FIRE SAFETY INSPECTION REPORT

PAWLA KNITWEAR (PVT.) LTD.
ISDAIR, FATULLAH

ACCORD
on Fire and Building Safety in Bangladesh

April 28, 2014

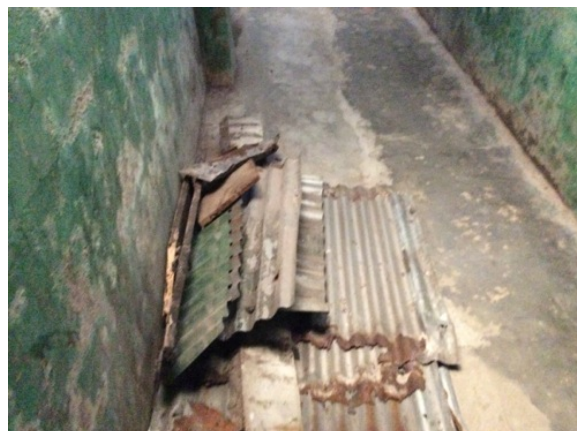
F-3	Fire Rated Construction	The boiler, generator and transformer rooms are not separated by fire-rated construction from Dining area in the seventh floor, North west stair lobby in the ground floor and Office space in the first floor respectively.	Separate the boiler, generator and transformer rooms by a minimum 2-hr fire-rated construction. Seal and/or protected all openings to maintain the required fire separations	Within 3 months
-----	-------------------------	--	--	-----------------

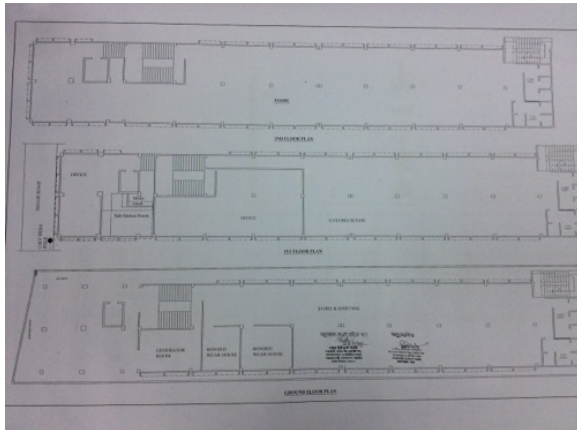
F-9	Egress	Common path of egress travel exceeds 30 m. in the ground floor.	Reconfigure the egress arrangement to reduce the maximum common path of travel to not more than 30 m.	Within 3 months
-----	--------	---	---	-----------------

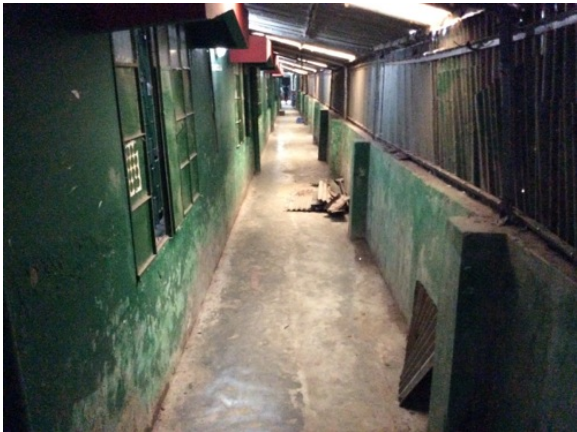
F-10	Egress	A single means of egress is provided from the ground floor.	Provide an additional means of egress from the ground floor.	Within 3 months
F-11	Egress	All the Exit stairs discharged in the ground floor inside the building. North west stair discharged inside the building was open to the generator. North east stair discharged in a 46 in. wide corridor which lead to the interior and was open to the knitting section.	Provide 2-hr fire-rated exit passageway leading directly outside.	Within 6 months

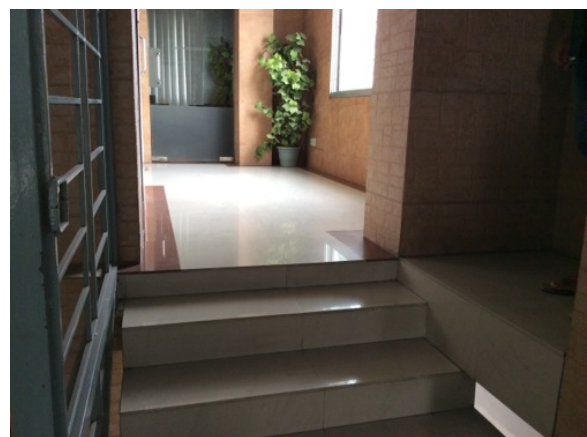
F-17	Egress Lighting	Based on the number and location of emergency lights observed, adequate illumination levels are not anticipated in the stairs.	Test the emergency lighting system on each floor and provide additional emergency fixtures to provide adequate illumination along the means of egress. Provide a minimum illumination of 10 lux at the floor level within exit stairs and exit discharge paths and minimum 2.5 lux along exit access aisles.	Within 3 months
------	-----------------	--	--	-----------------
